Product/Process Change Notice (PCN)

PCN Number: PCN_ConHDMI_20250507

Affected Series: WR-COM HDMI

Affected Part Number: 685119135725

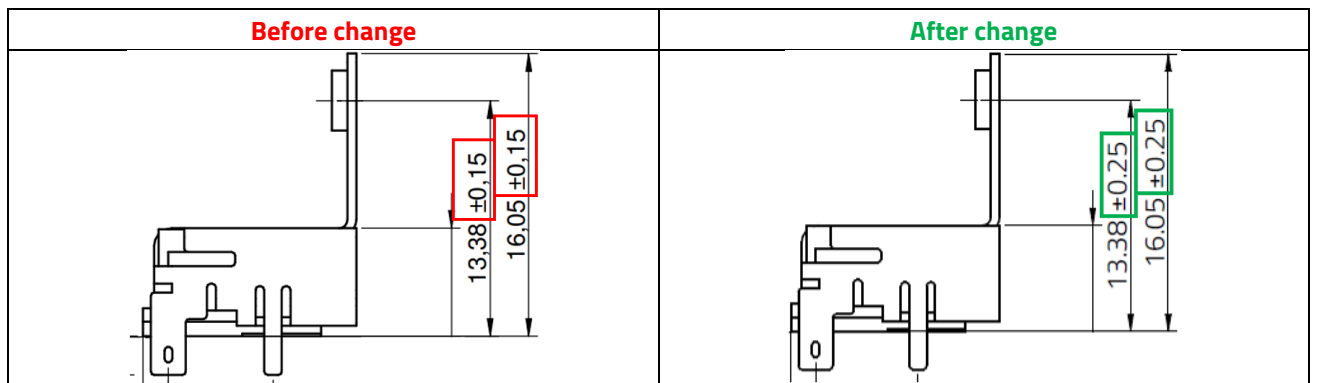
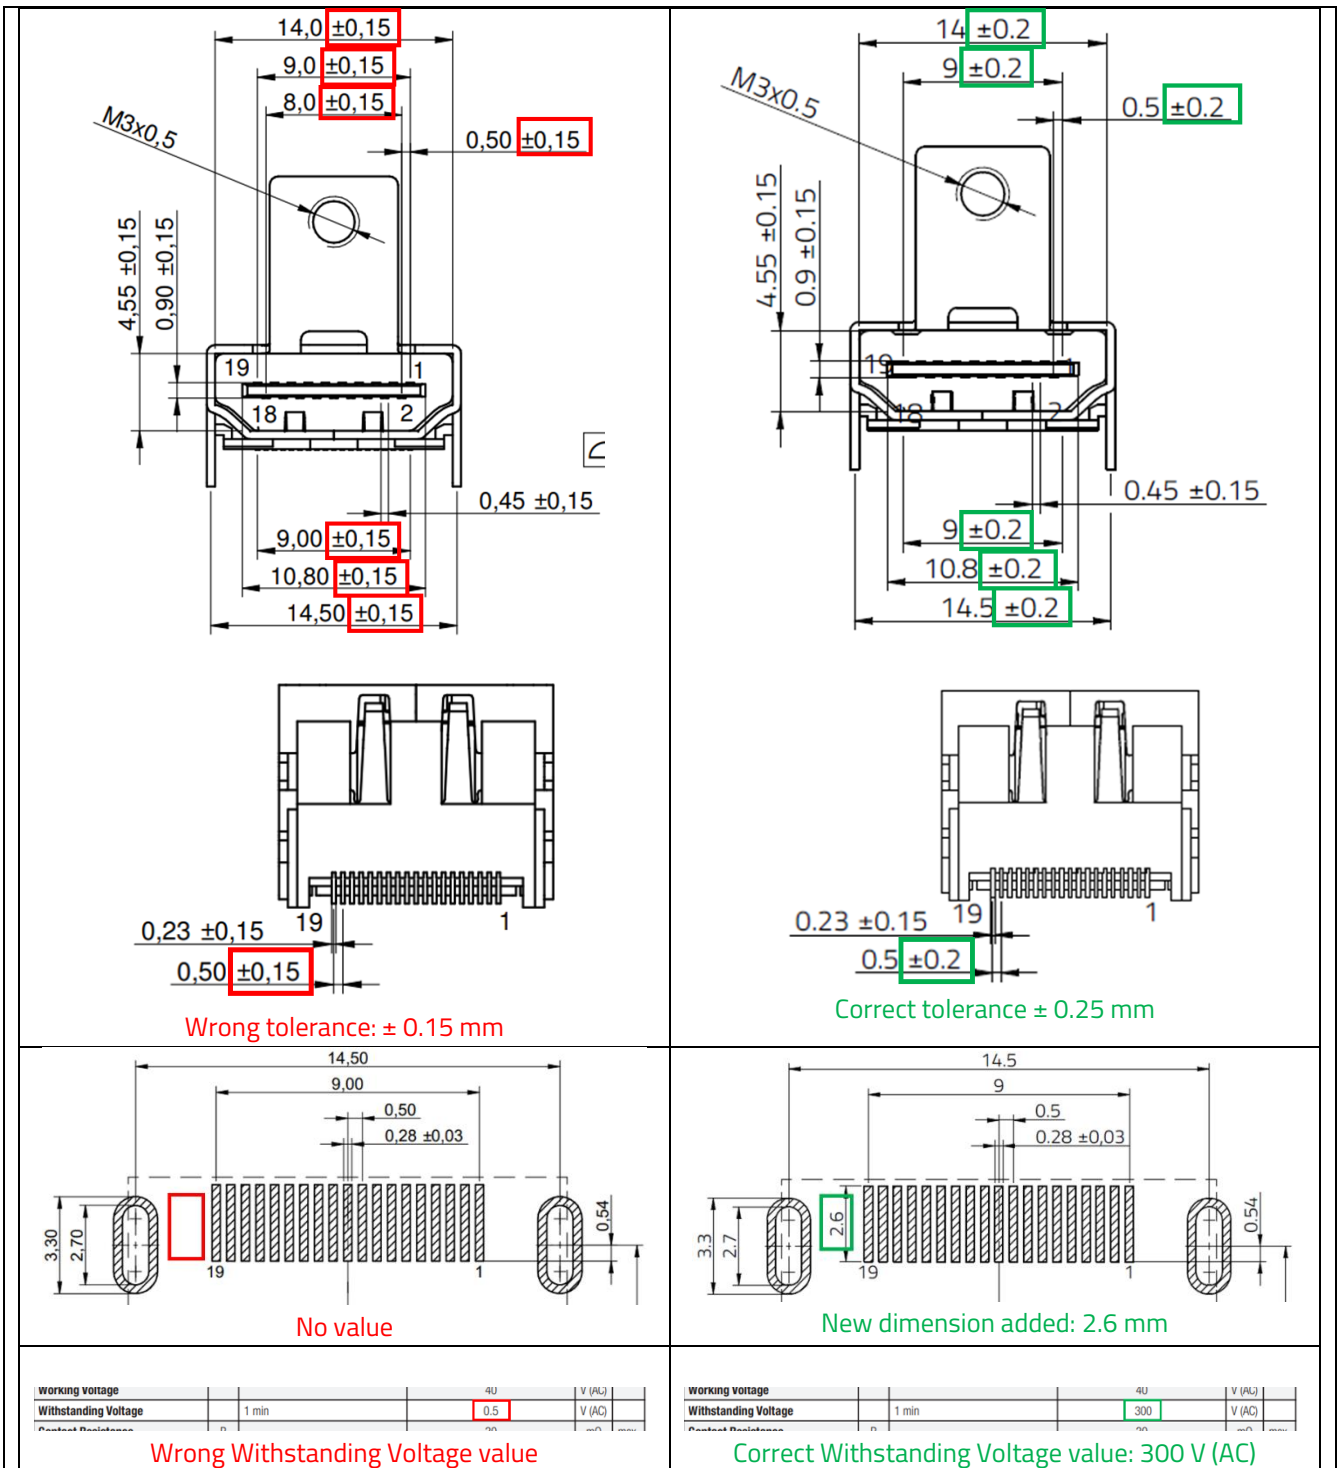
Because of a database mismatch, Würth Elektronik eiSos will make a correction on Tolerance, Withstanding Voltage value and will add a dimension in the layout drawing.

This is a datasheet correction only. There will be no change in form, fit, function, quality or reliability of the product.
